593 & 601-603 Laurier Avenue West

UDRP REPORT
Official Plan and Zoning By-law Amendment Applications
June 15, 2025

URBAN DESIGN BRIEF

21 MARCH 2025

601 LAURIER AVENUE TRANSITION / ANGULAR PLANE STUDY

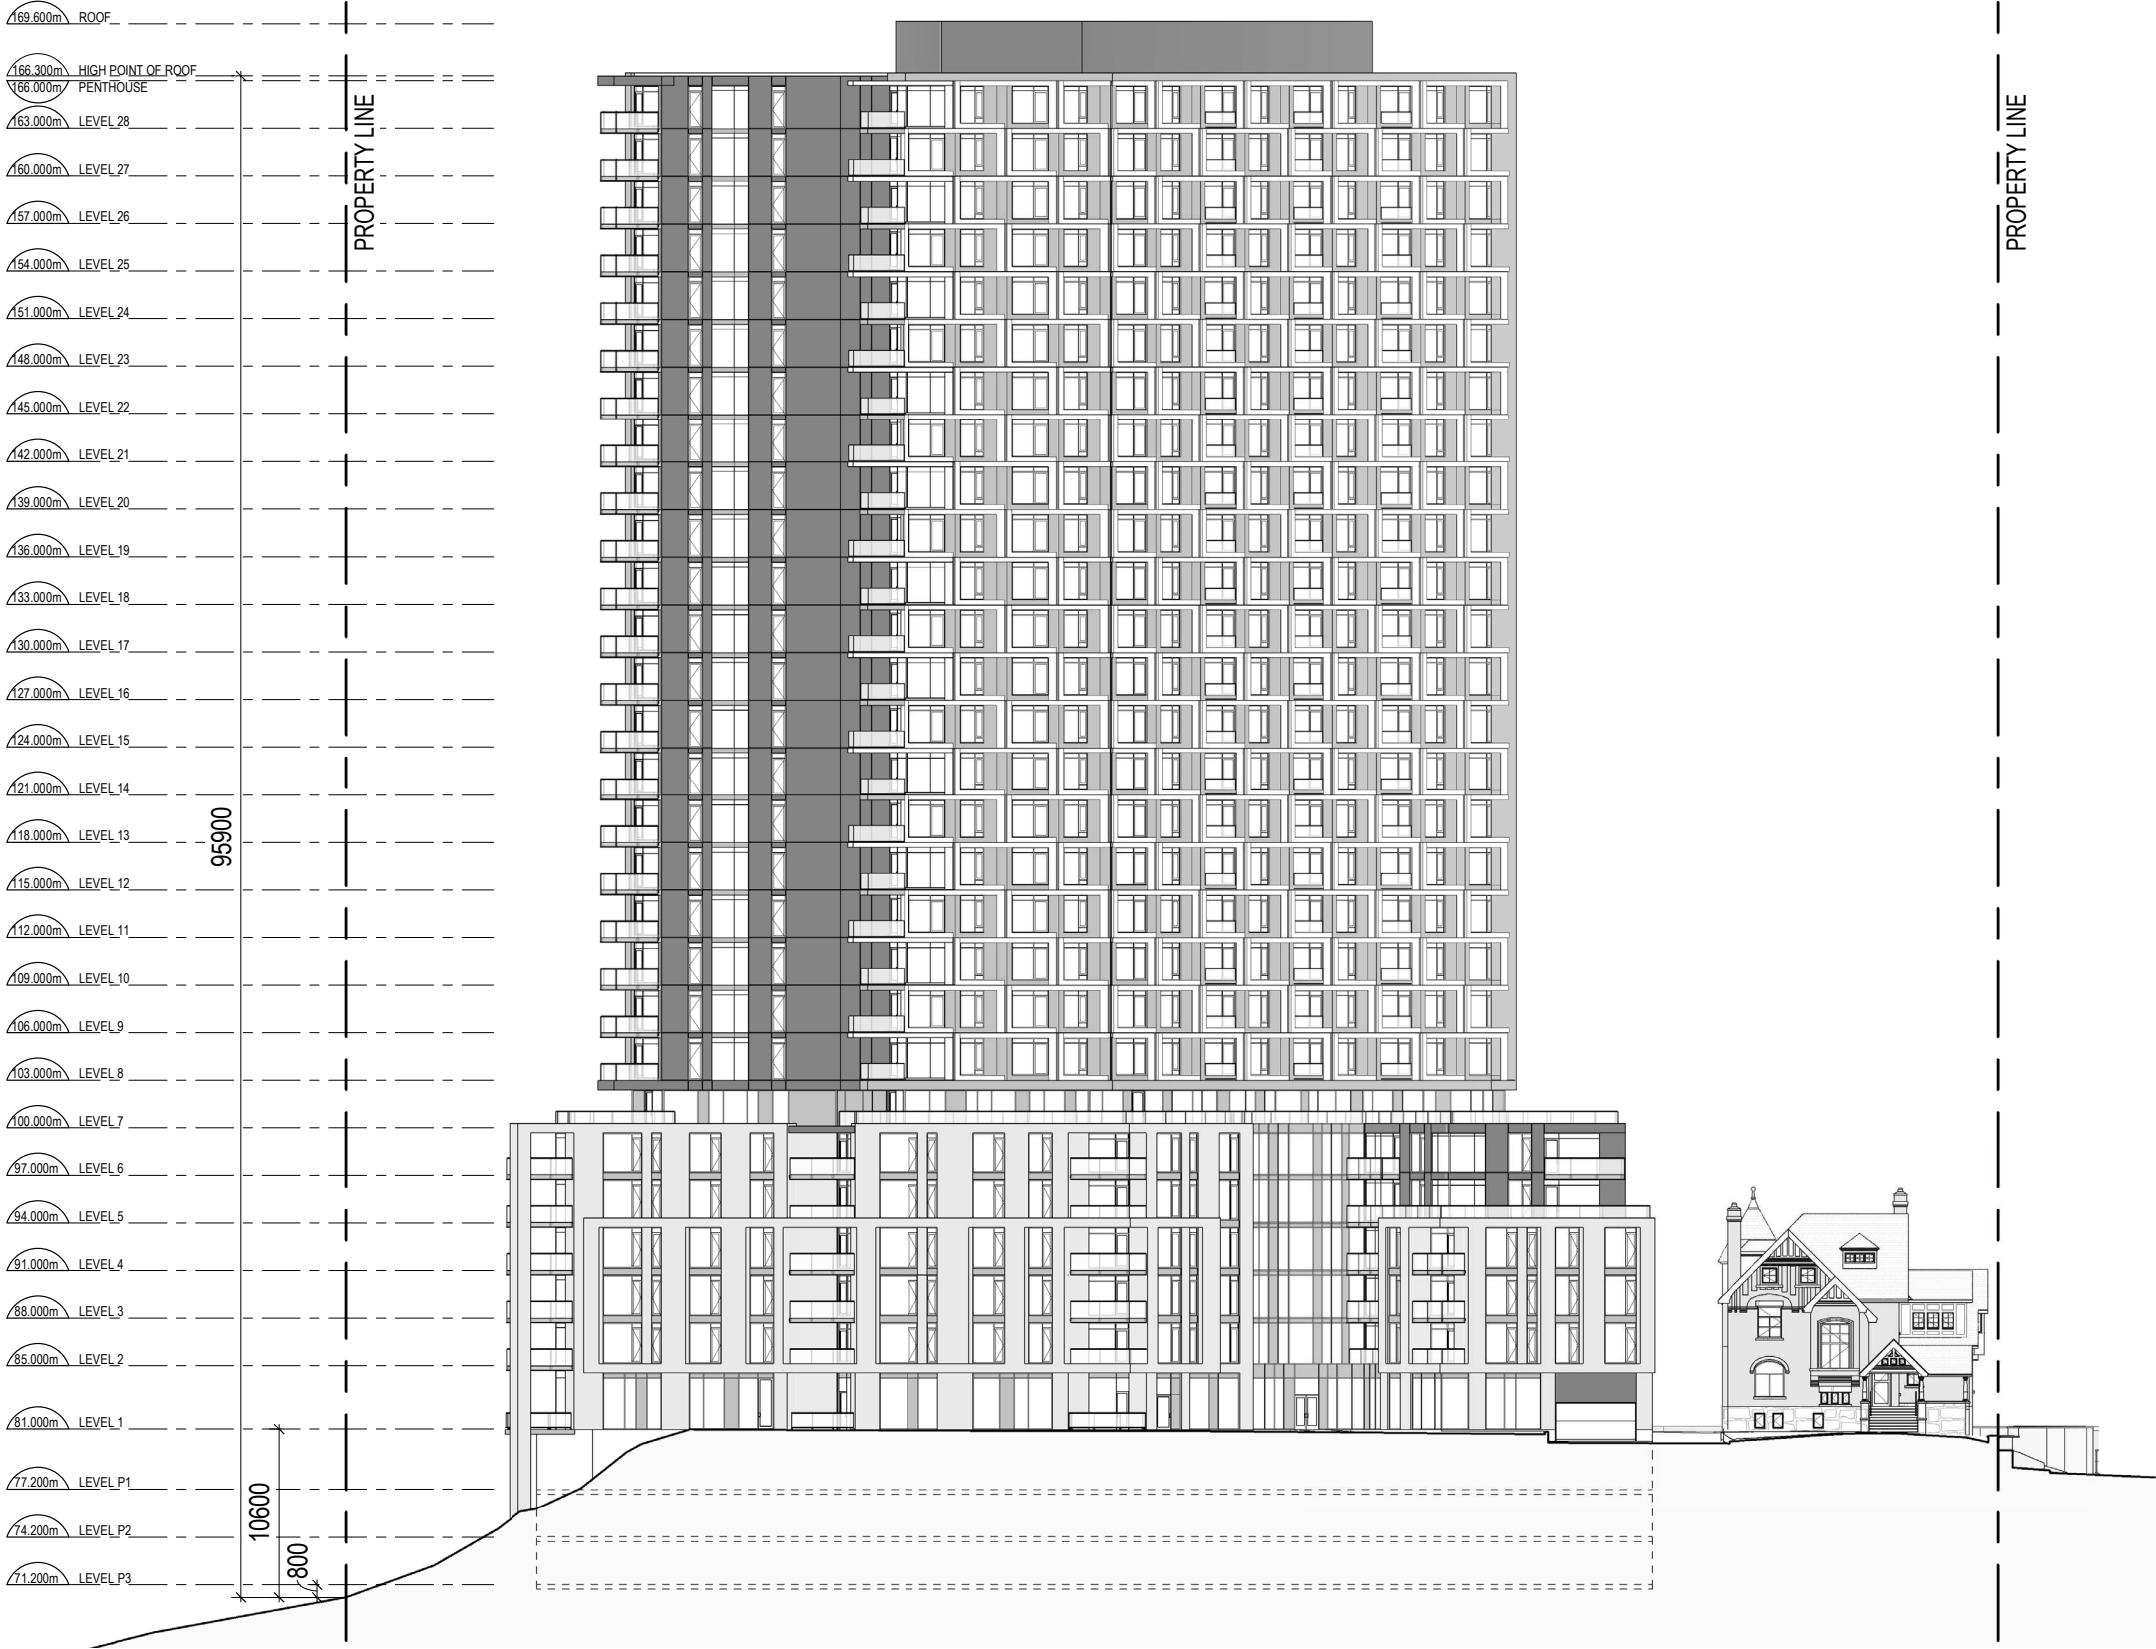
Height: There would be two overlapping tools to determine the best approach to analysing appropriate height being the NCC Parliamentary view shed analysis, extrapolated over the site, and a 45-degree angular plane drawn from the residential properties to the south on Cambridge. We recommend illustrating both and providing a rationale for the approach preferred.

We have provided graphic material illustrating the building’s relationship with the neighboring buildings, including the 45-degree angular plane calculated from the existing buildings along Cambridge to the south. Our subject property falls outside the boundaries of the NCC Parliamentary view sheds, so this analysis was not considered.

DESIGN EVOLUTION

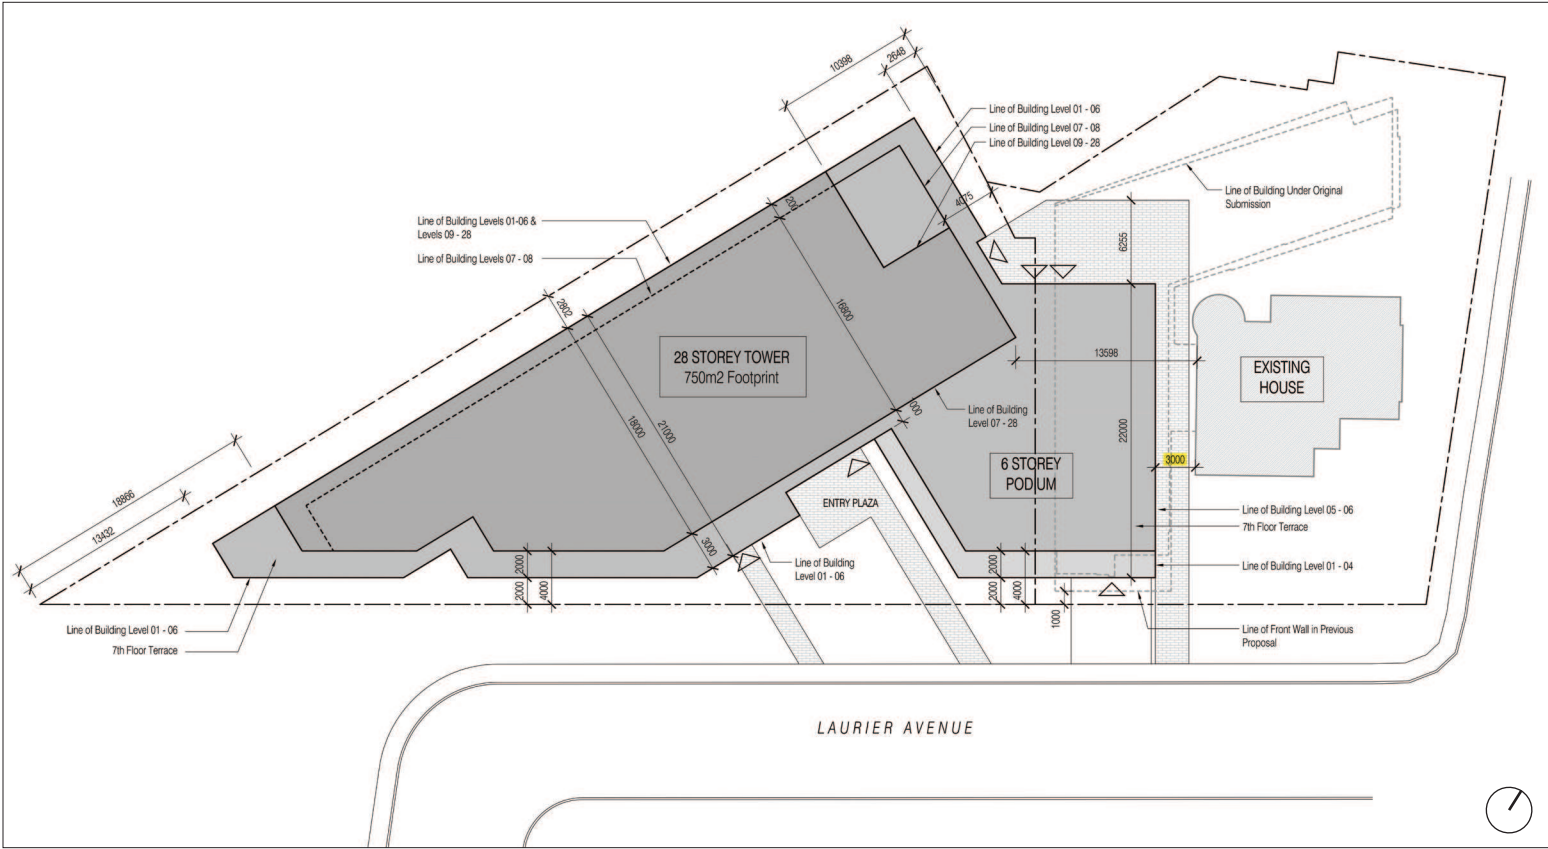
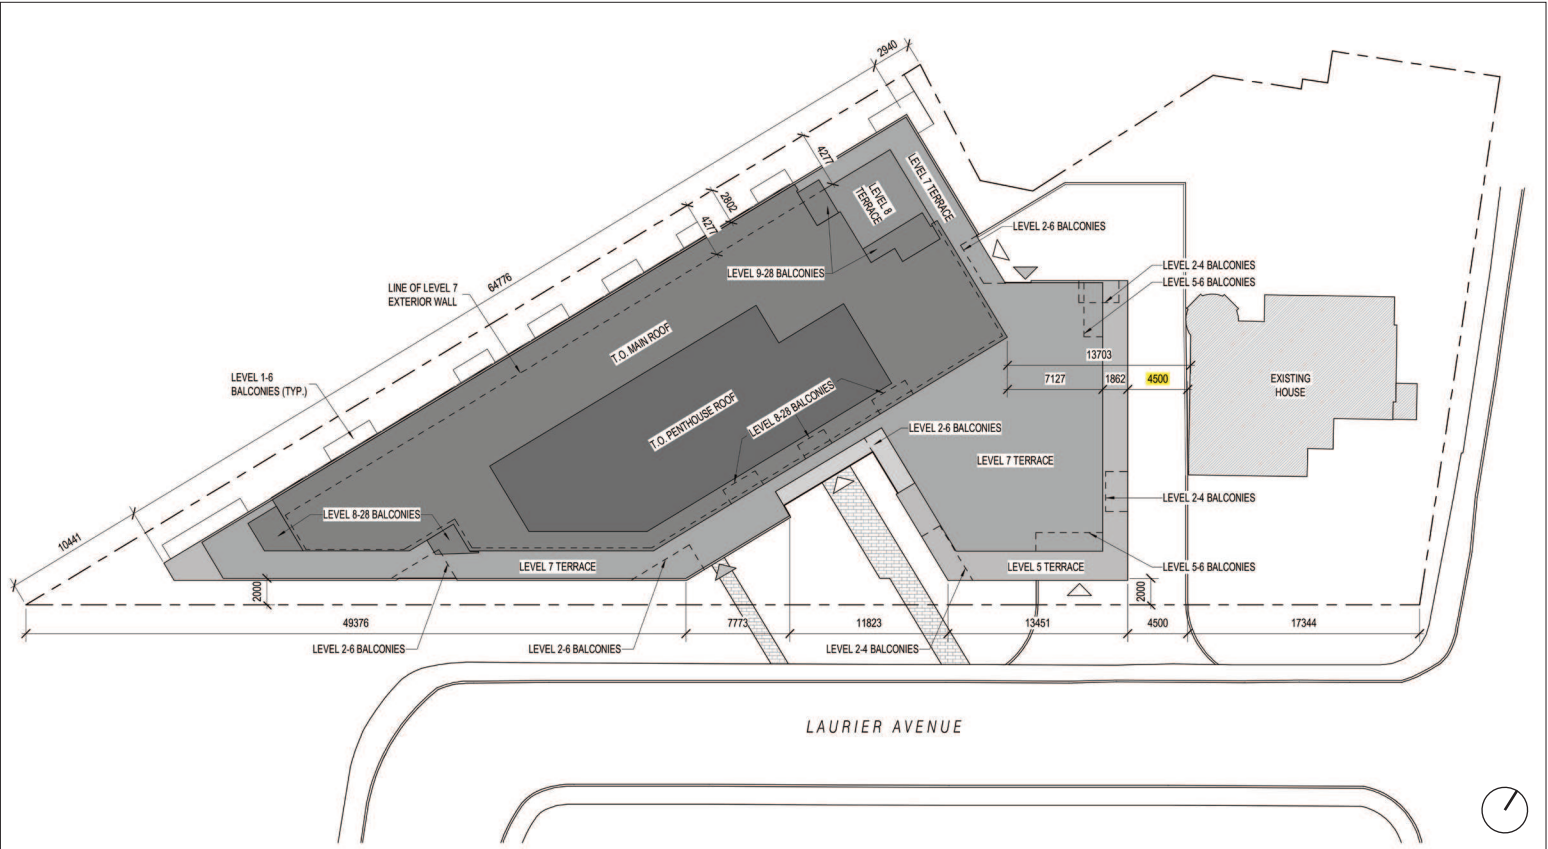
The podium may be high for the neighbourhood context and especially the relationship to the heritage house on the property. We recommend providing additional design/massing details so we may better understand the approach being taken.

We have increased the separation from the heritage house to 4.5m from 3m and introduced a setback and material change above level 4 to better integrate the podium with the neighborhood context. These adjustments help to mitigate the podium height and ensure a more harmonious relationship with the heritage house.

The initial massing concept positioned the proposed development 3 meters from the existing Heritage House for the first six storeys of the podium. This approach was primarily driven by the objective to maximize leasable space, providing ample room for residential units while maintaining vehicular access to essential building services at the rear. This configuration, however, raised concerns about the proximity to the Heritage House and its impact on both the historical context and practical access, and required further consideration to improve spatial dynamics and circulation.

In response to these concerns, the current design iteration has been refined to enhance both spatial and aesthetic relationships. The podium has been shifted an additional 1.5 meters away from the Heritage House, resulting in a total separation of 4.5 meters. Furthermore, levels five and six of the podium are now recessed an additional 1.8 meters, creating a more gradual transition to the tower levels above. The first four levels of the podium, which align with the height of the Heritage House, will feature red-tone brick complimenting the red brick of the existing structure. This material choice reinforces the architectural dialogue between the new and existing building.

West Elevation

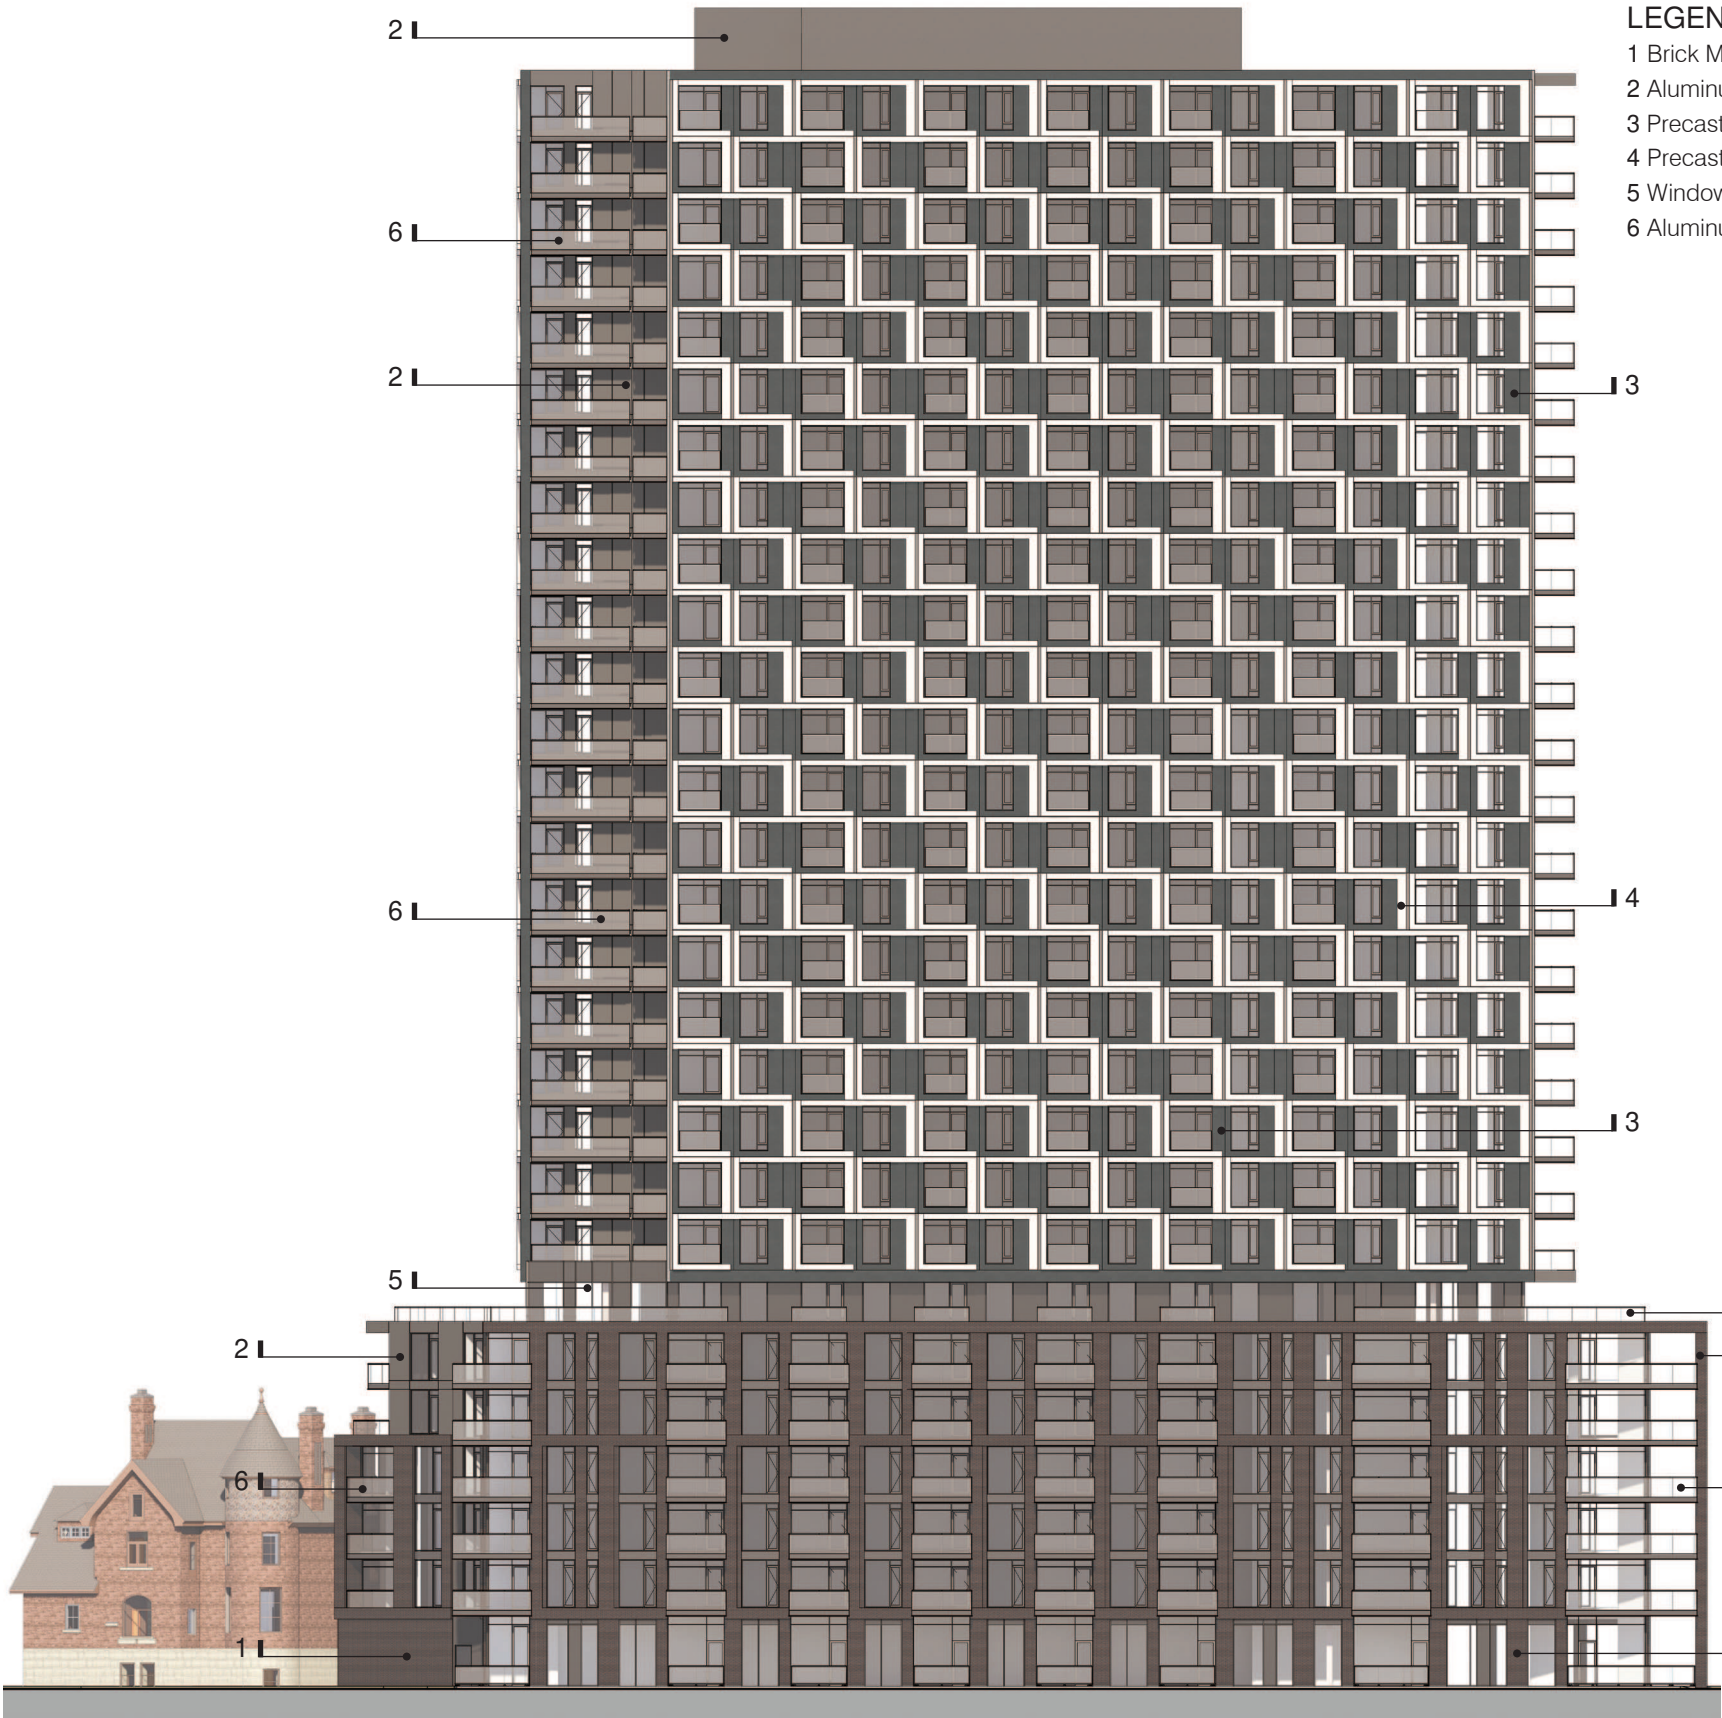
6.	The Panel has concerns with the width/expansiveness of the north/west elevation and provided a variety of suggestions to help visually reduce the apparent width of the west façade.	We understand the concern about the length of the elevation, and we are addressing this by incorporating reflective materials on the glass railings. This will help reduce the apparent width by introducing visual interest and dynamism to the elevation.
	Site Design & Public Realm
